Re: Black Bill & Doney Park Water Users Association
Job No. 403-69

HEINRICH'S GEOEXPLORATION COMPANY POST OFFICE BOX 5671, TUCSON, ARIZONA, 85703 Phone: 602 / 623-0578 Cable: GEOEX, Tucson geophysical engineers vancouver sydney		403-69
LOCATION PLAN OF RESISTIVITY SURVEY		
FOR BLACK BILL & DONEY PARKS WATER USERS ASSOCIATION (BILL RAMSEY) FLAGSTAFF, ARIZONA		
SCALE 1" = 1000'	DRAWN BY J.L. PETRY	DATE 6-69

LOCATION PLAN OF RESISTIVITY SURVEY

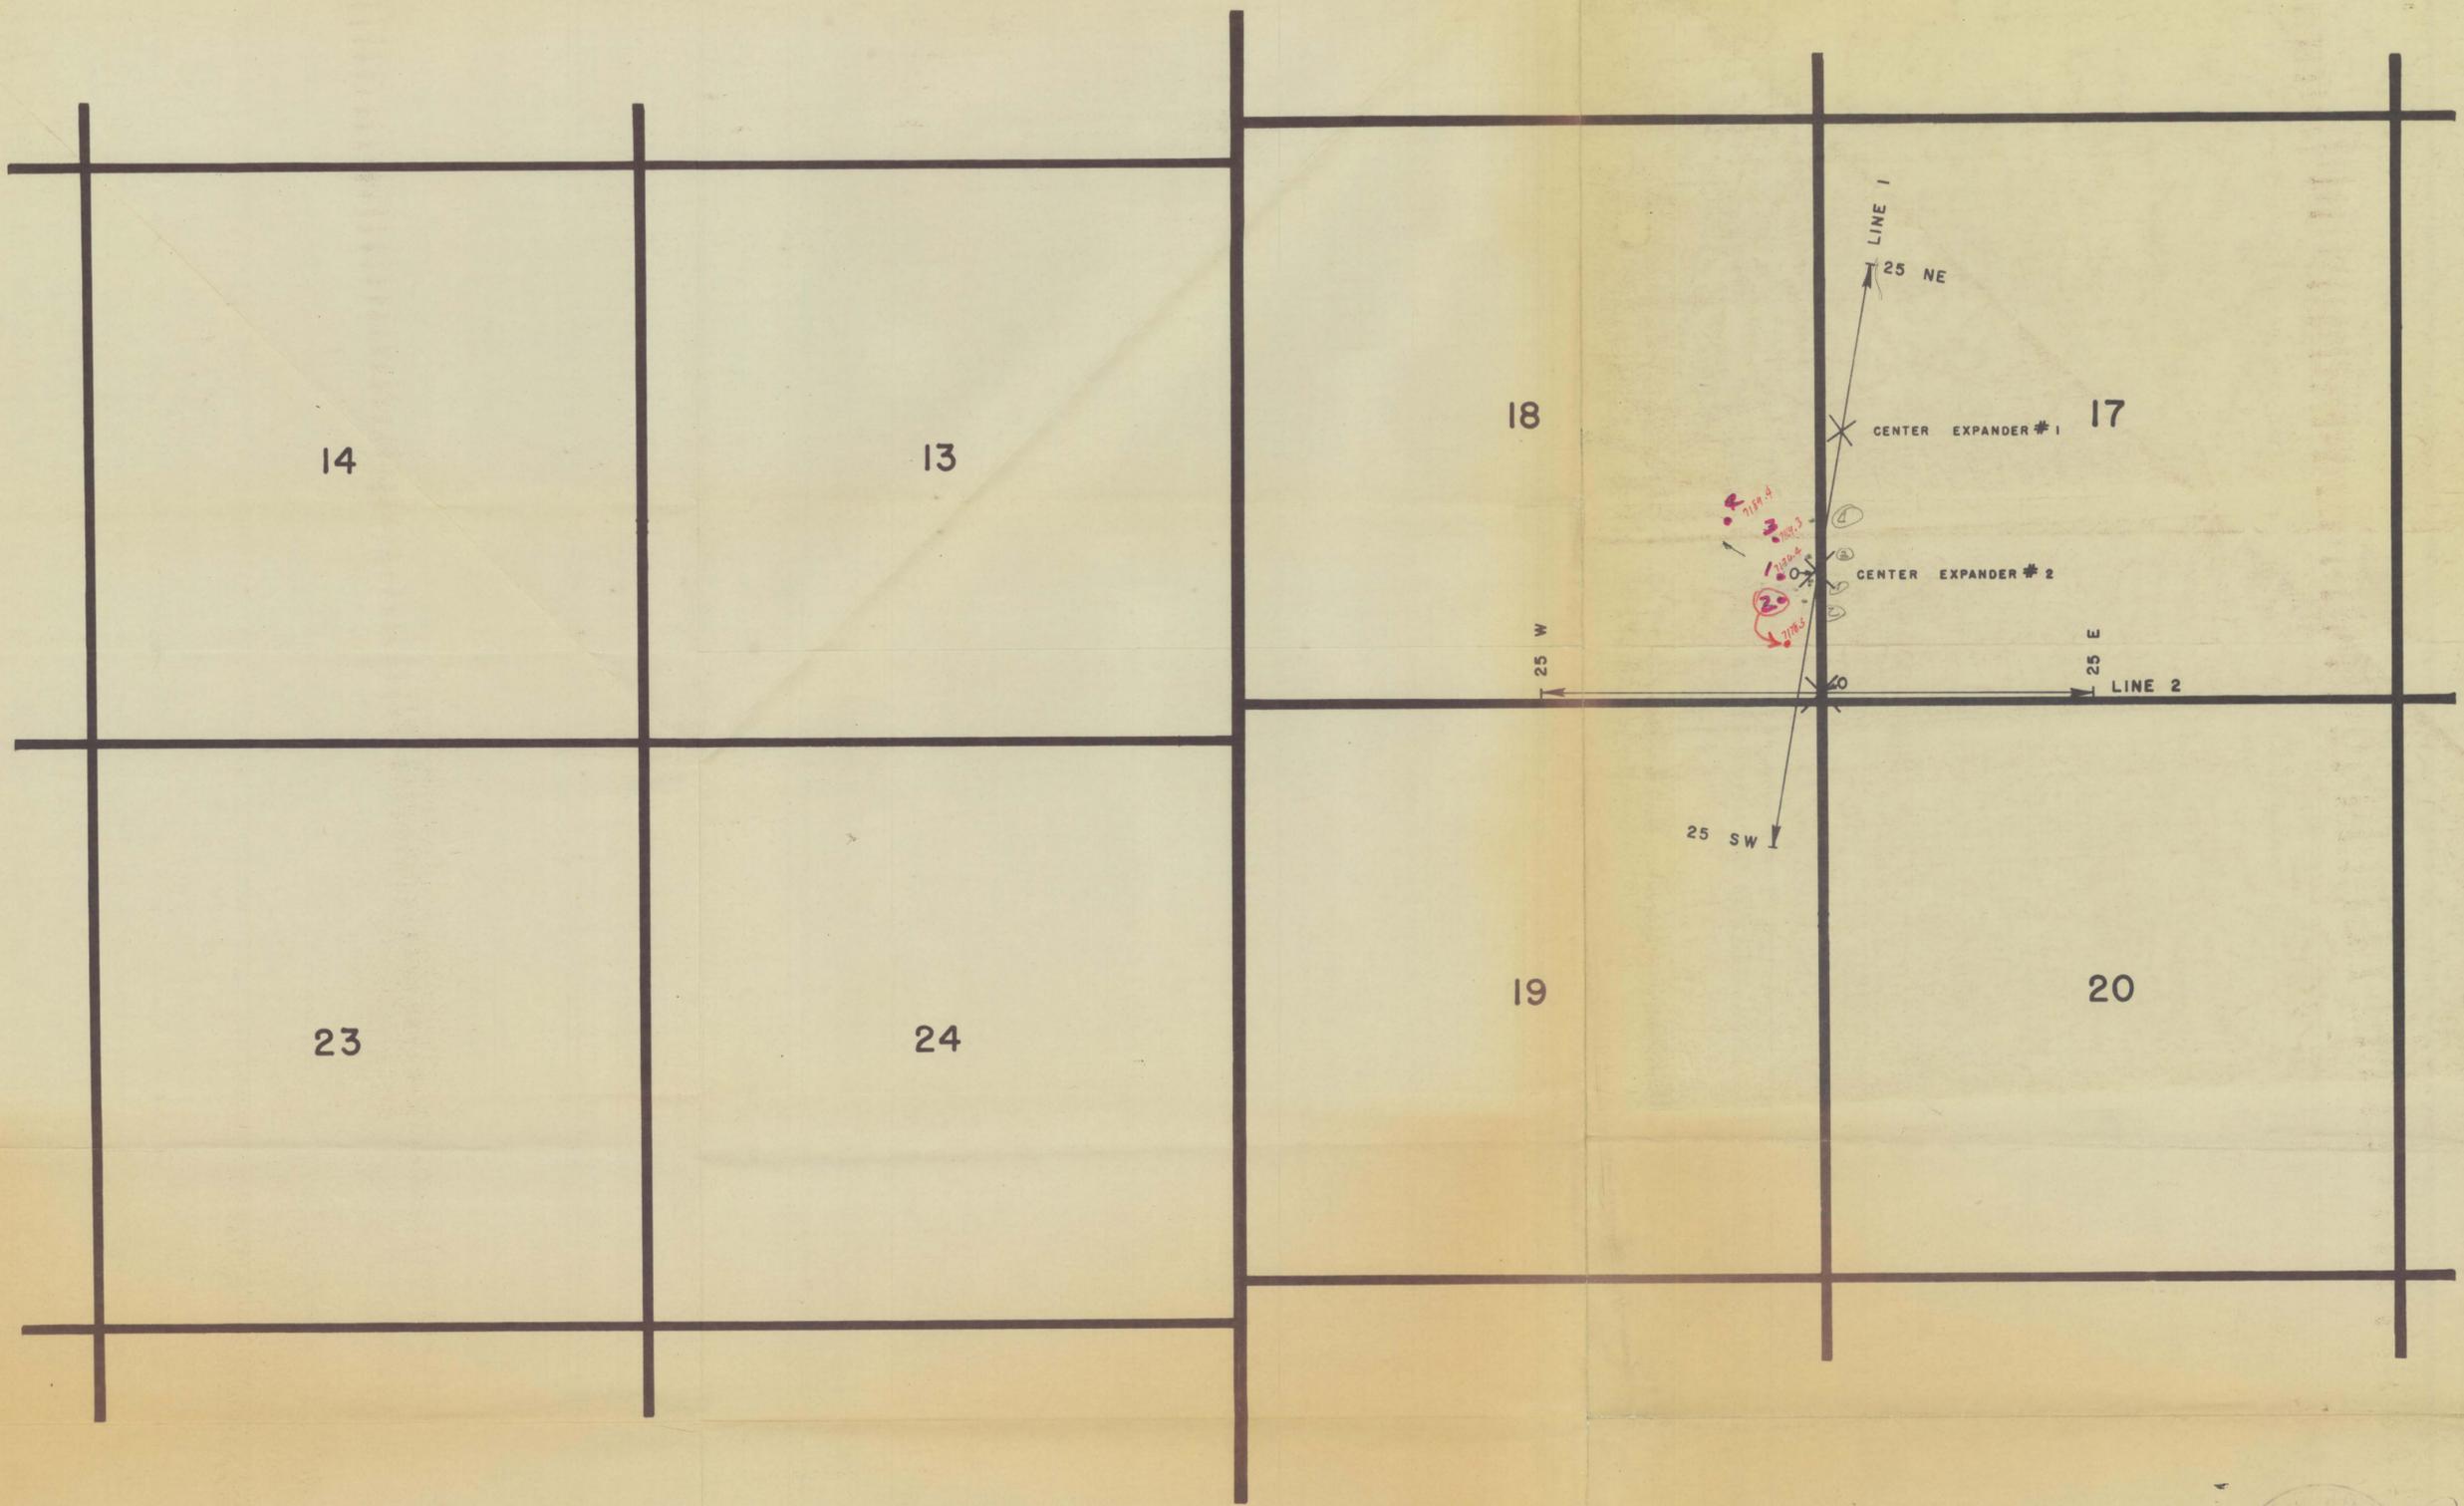
I am also enclosing a copy of your location map which shows the approximate location of the drill holes marked in red. As you will note, they are not exactly as you had recommended but in very close proximity.

LINE I

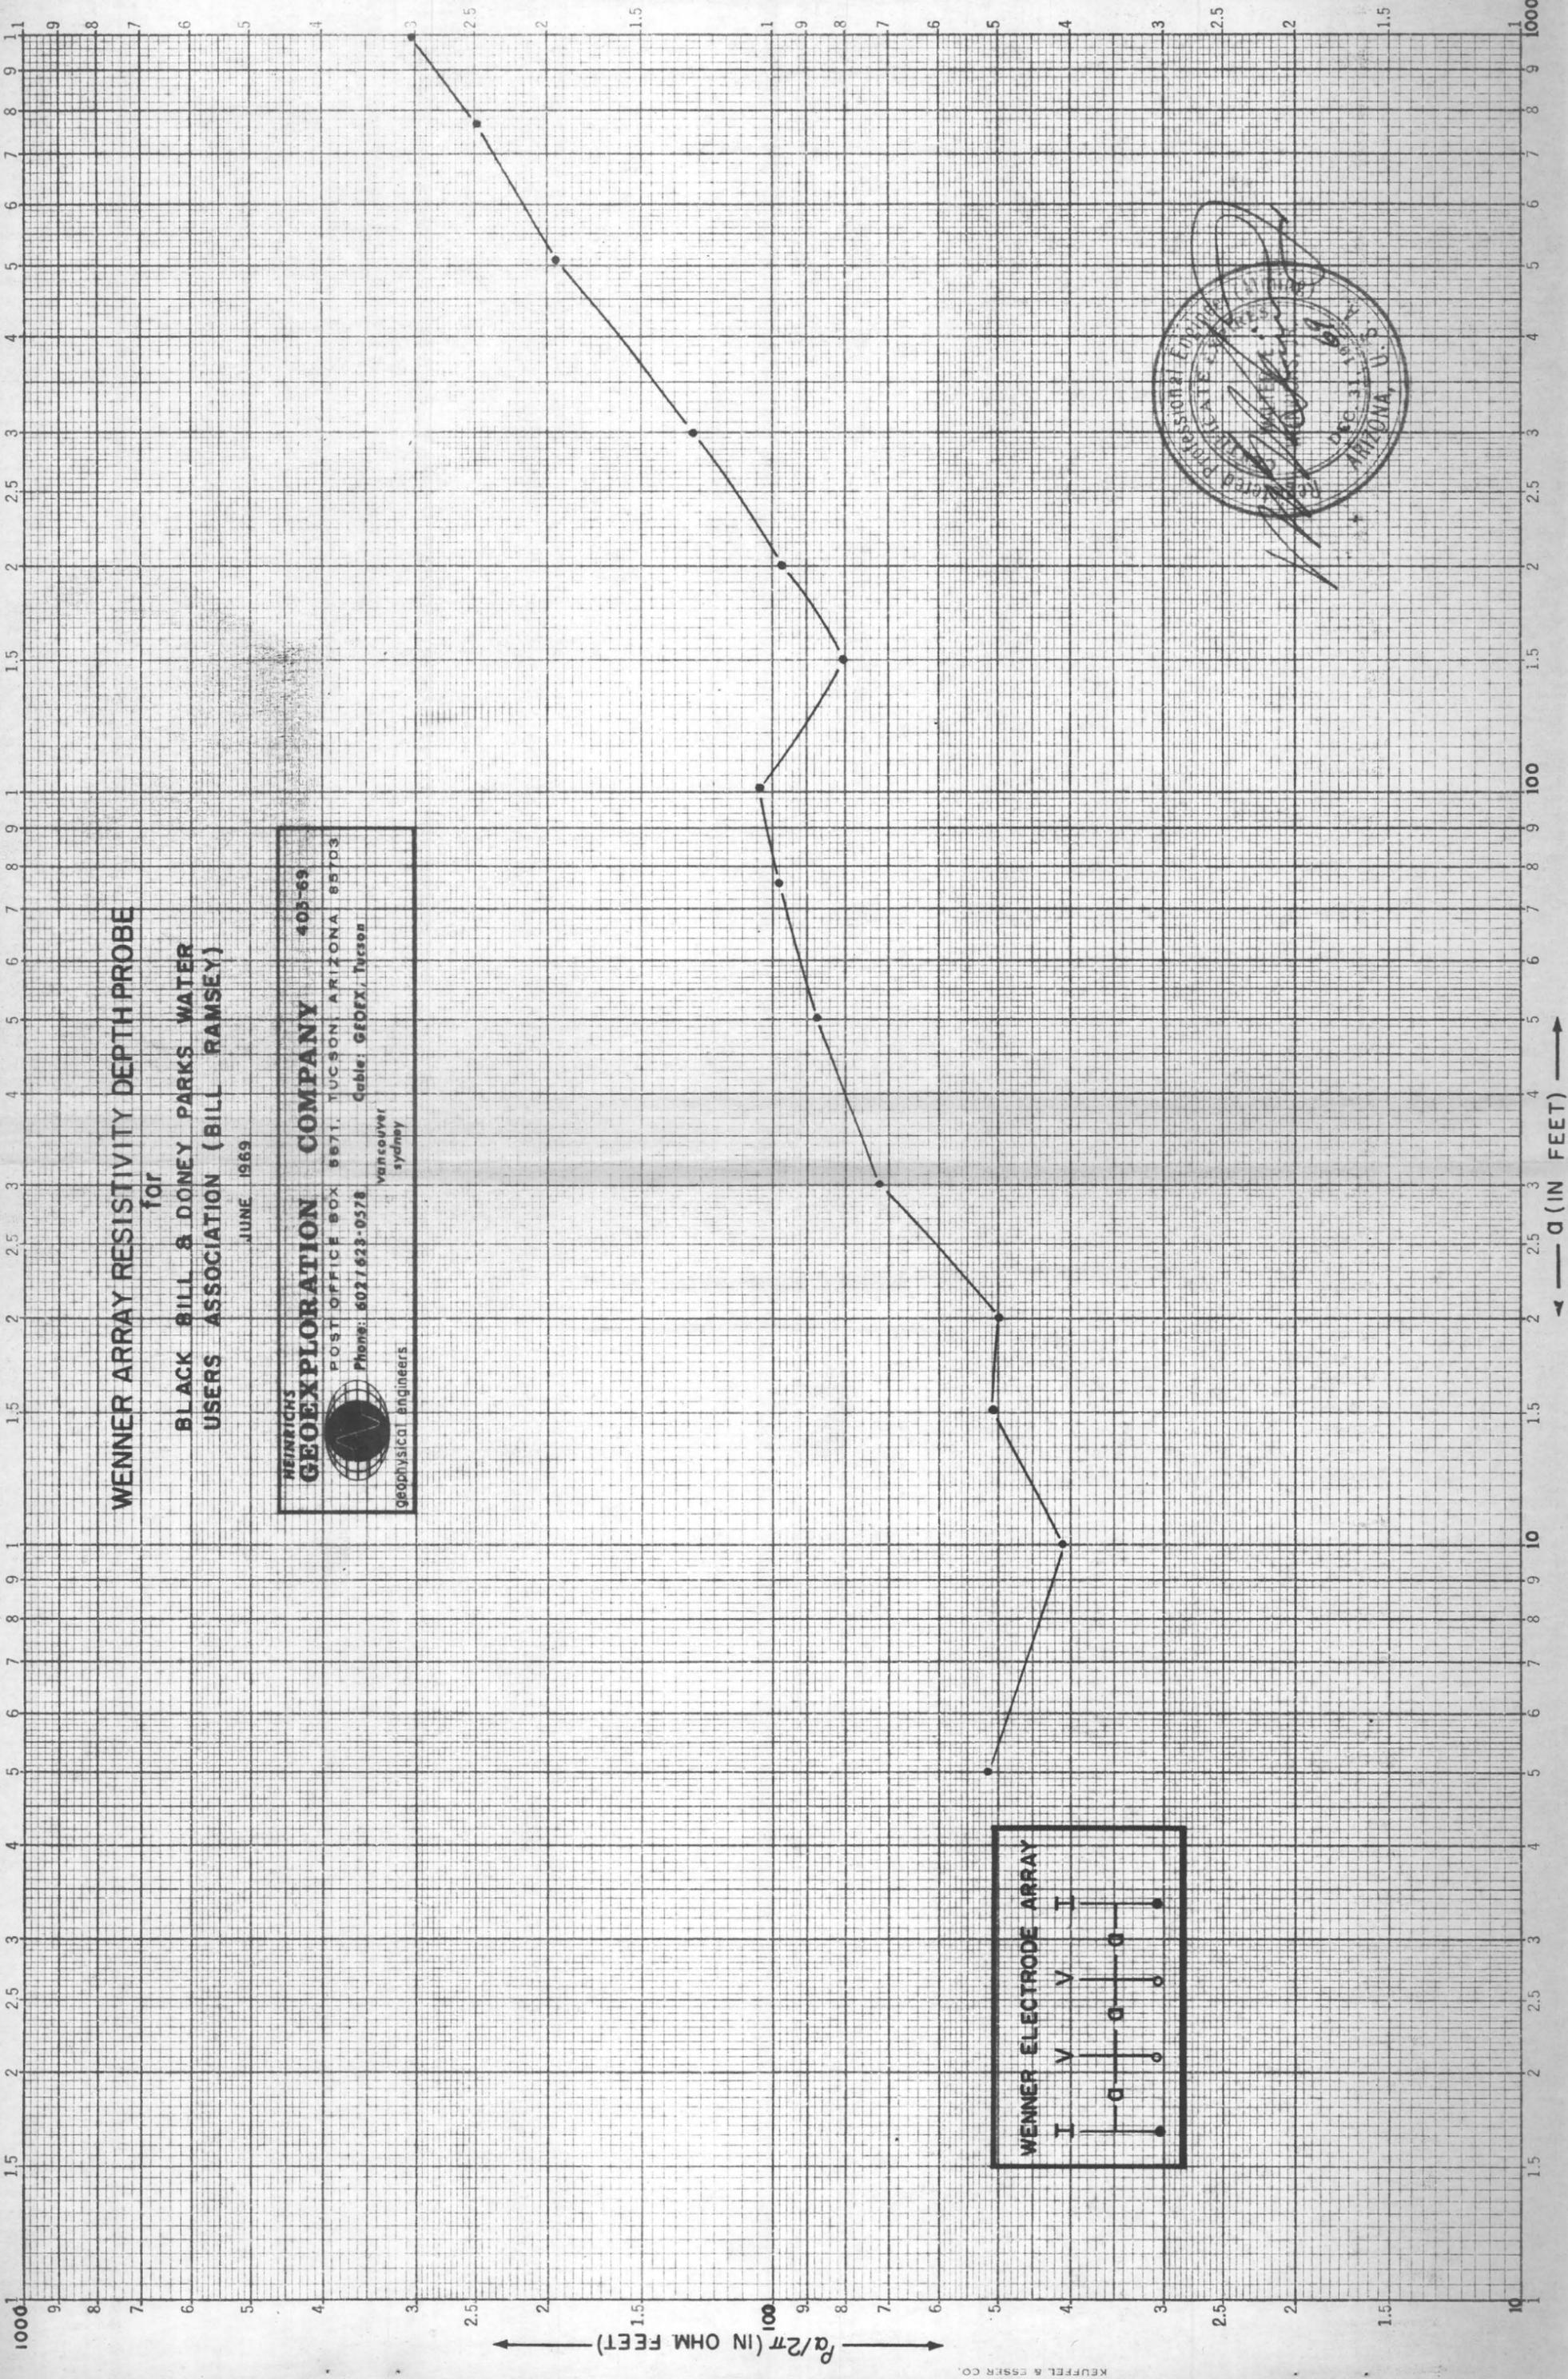
Line #1 is oriented N 10° E as shown on the plan map. A north-south oriented fence crossing the line at about a 10° angle near 0.0 NE probably has a marked effect on the resistivity data but does not seriously impair relative depth calculations since it is nearly parallel to the line and quite long compared to the dipole spacings used. The resistivity low centered at about 1.25 SW is a valid feature that caused the poor depth probe data on Expander #1 and may represent either a change in bedrock resistivity or a channel in the bedrock filled with alluvium. The north end of the line

If the field crew, seeing the wire fence, could run the survey in such a way as to eliminate the effect of the fence, could the same technique be used to eliminate the effect of the pipe? I assume there is an explanation but you will have to educate me.

In answer to your question regarding the elimination of fence effects, the problem of unwanted effects of fences, pipes, cables or other grounded conductors is in theory and technically quite easy. All that is needed is to dig them up and move them away from the area being surveyed. Practically this is nearly always impossible. In the case of fences, it is possible to insert insulators into each strand of the fence for several hundred feet every 100 feet to eliminate most of the interference. However, this is expensive and more commonly, in the field, we try to cross the fence at right angles with electrodes equally spaced straddling the fence line. To a degree this will minimize but not eliminate interference when it is possible to cross at right angles.

We could have minimized the pipe effect by this approach and in fact this is actually about the way it worked out, accidentally. There is no practical way to really correct or eliminate the effects of a 42" gas main - short of digging it up.

Area originally proposed
and planned for Survey

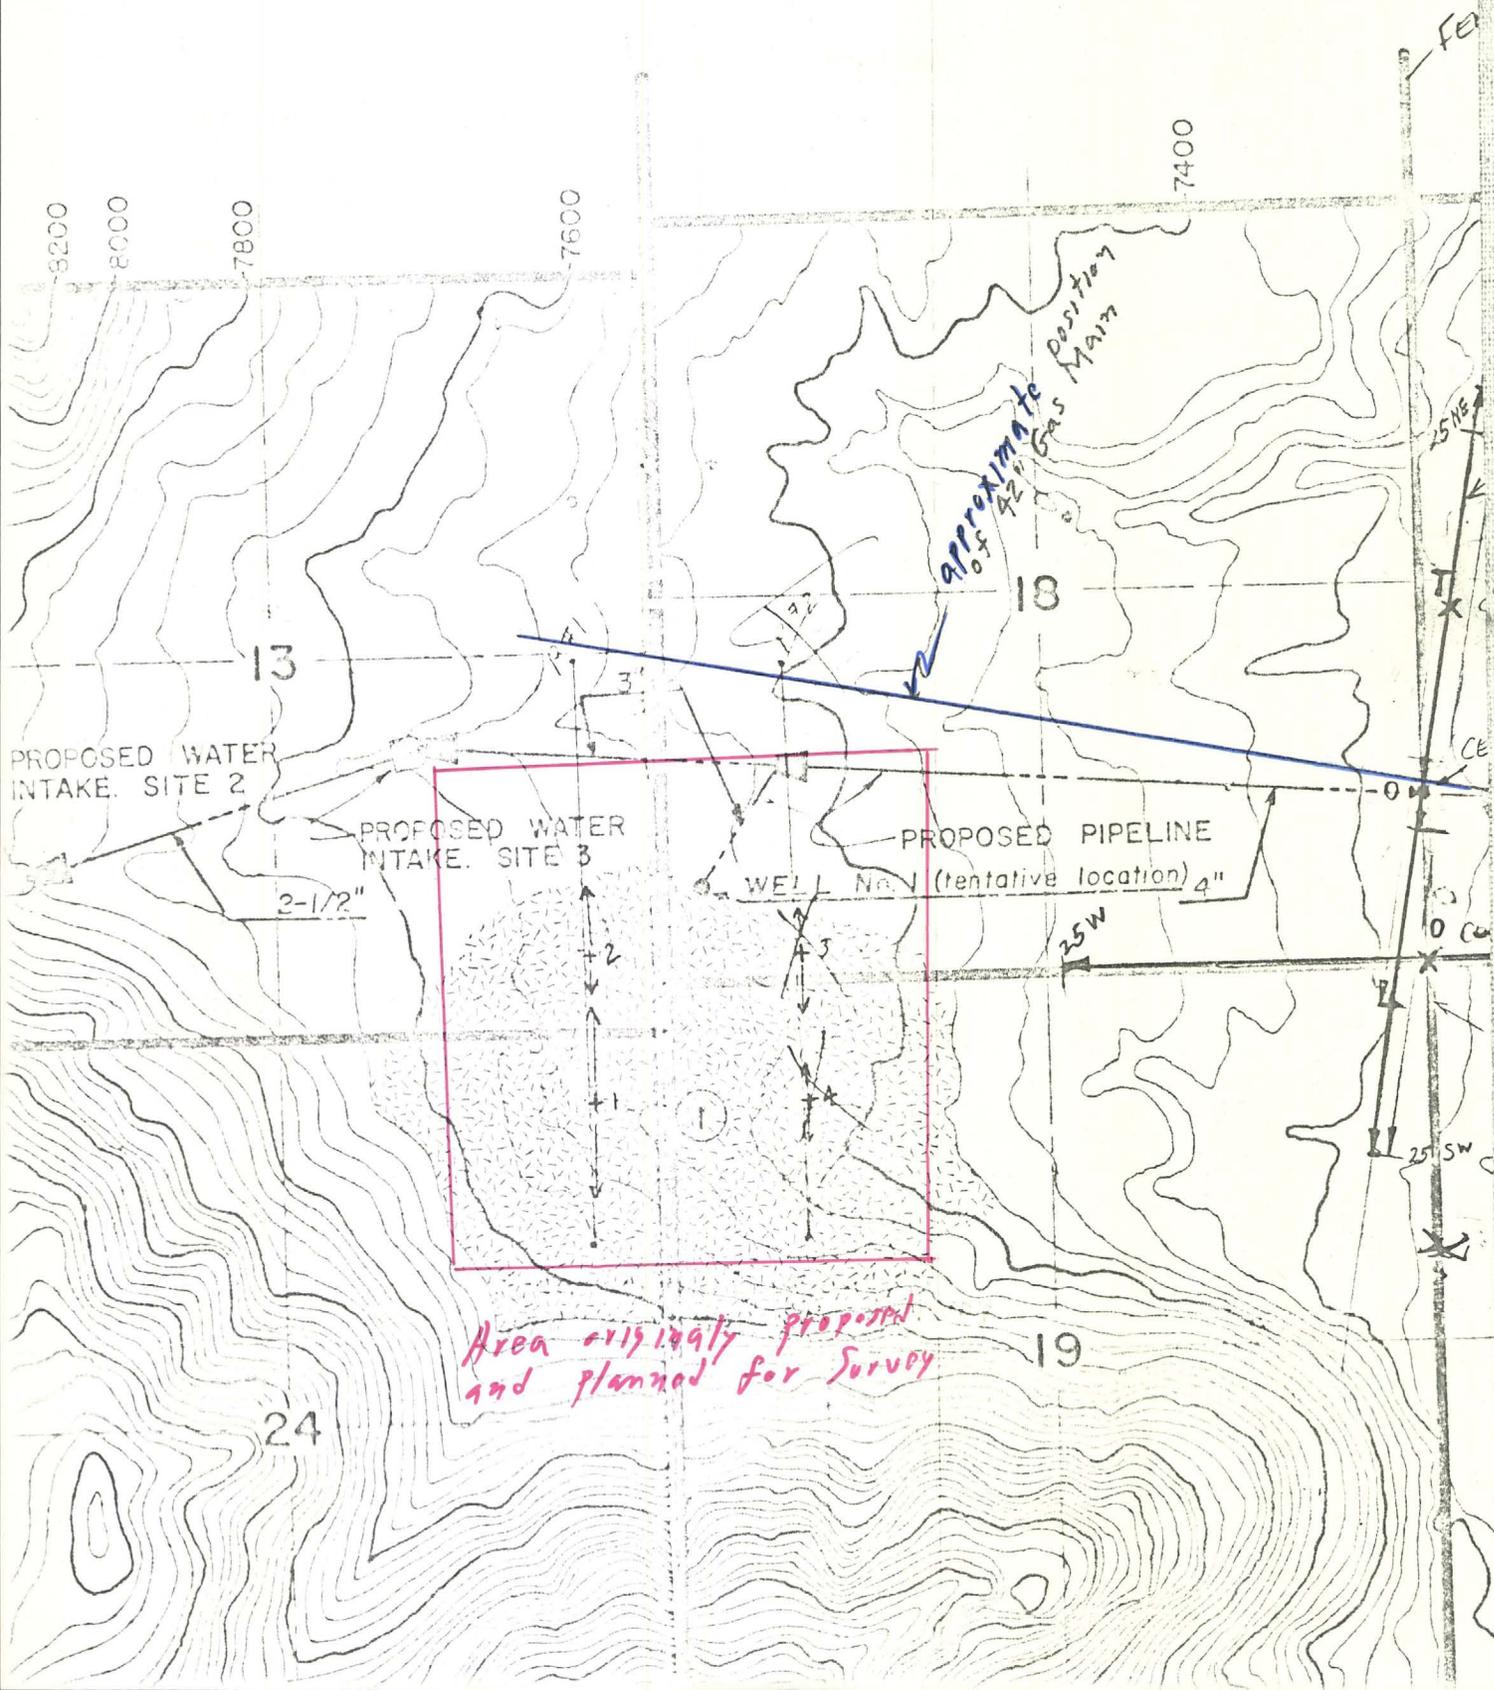
Enclosed is a map that was furnished Geoex by Mr. Ramsey and on which Geoex has shown in red the area that was originally designated by Mr. Ramsey for the geophysical survey and agreed upon between Mr. Head and Mr. Ramsey. The map showed only a proposed water line to be built at some future date by the Association. The map does not show an existing pipeline on the designated area.

of Mr. J. Bauersachs, to perform the work in accordance with the instructions of Mr. Head. When Mr. Bauersachs reported to perform the work, Mr. Ramsey had made a decision to have the geophysical survey made in a different location. The work performed by the field crew was done at the new area designated by Mr. Ramsey. The lines run by the field crew are shown in black on the map and are completely outside the area originally designated. The approximate position of the gas pipeline is shown in blue, having been added to the map at my request.
